**Status** 2-Disposition Needed 9-Closed **Trend** 07-Out Of Tolerance  
**Department** NCSX **Division** WBS 125  
**Source/Org** FABRICATION, OPERATIONS & MAINTENANCE  
**Item Dwg/Part#** VVSA T/C Feedthroughs **Procurement #** \_\_\_\_\_ **Cost Center** \_\_\_\_\_  
**RAP#** 3250 **Job Doc #** D-NCSX-FPA-QA1-00 **Vendor** \_\_\_\_\_  
**RAP Title** Field Period Assembly Component Receipt Inspection

VVSA-1, 2, & 3 - The NCSX vacuum vessel cryostat thermocouple feedthroughs (Insulator Seal Inc. Pt# 9332024) were found to have a magnetic permeability greater than is allowed by NCSX-ASPEC-GRD-05 paragraph 3.3.1.1 b (<1.05 Mu), see attachment 1 for details.

Sample #3 (shown above)

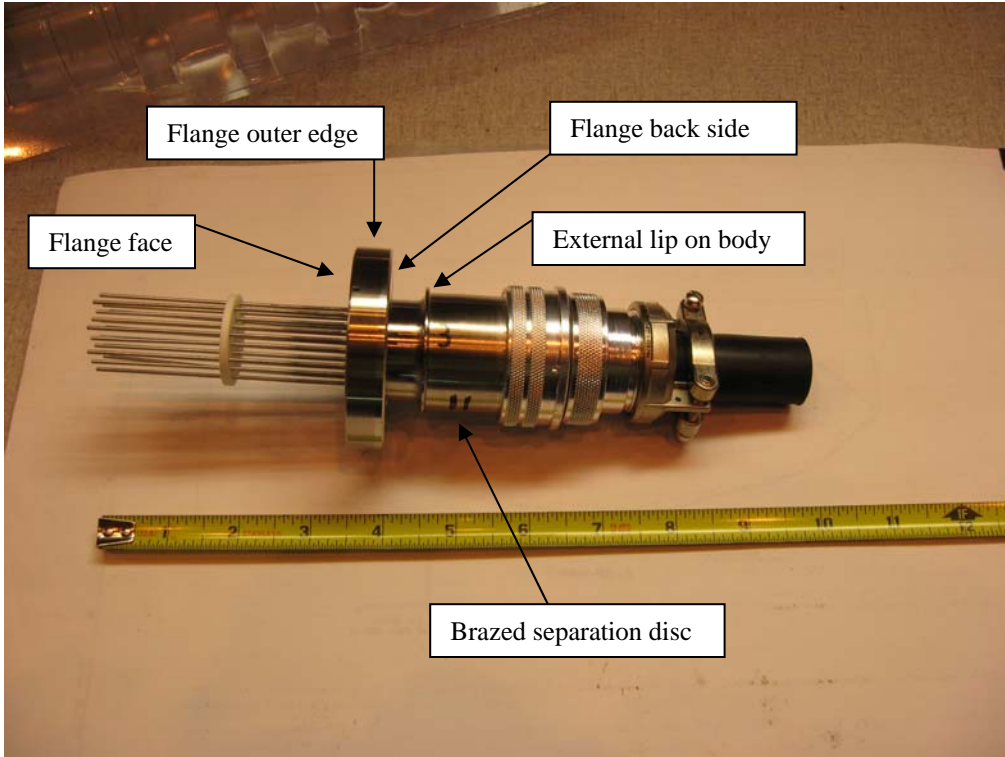
Sample #1

Conflat flange is size 2.73" OD x 0.5" thick

Conflat flange knife edge = >1.3, <1.4 Mu, w/ isolated spots of >1.4, <1.5 Mu

Conflat flange face and back side = >1.2, <1.3 Mu

Conflat flange outer edge = >1.1, <1.2 Mu

External lip on body (~1.7" dia. X ~1/8" thick) = >1.06, <1.08 Mu

Brazed separation disc (~1.6" dia. x ~1/4" wide) = >5.0 Mu

External lip on body (~1.7" dia. X ~1/8" thick) = >1.06, <1.08 Mu

Brazed separation disc (~1.6" dia. x ~1/4" wide) = >5.0 Mu
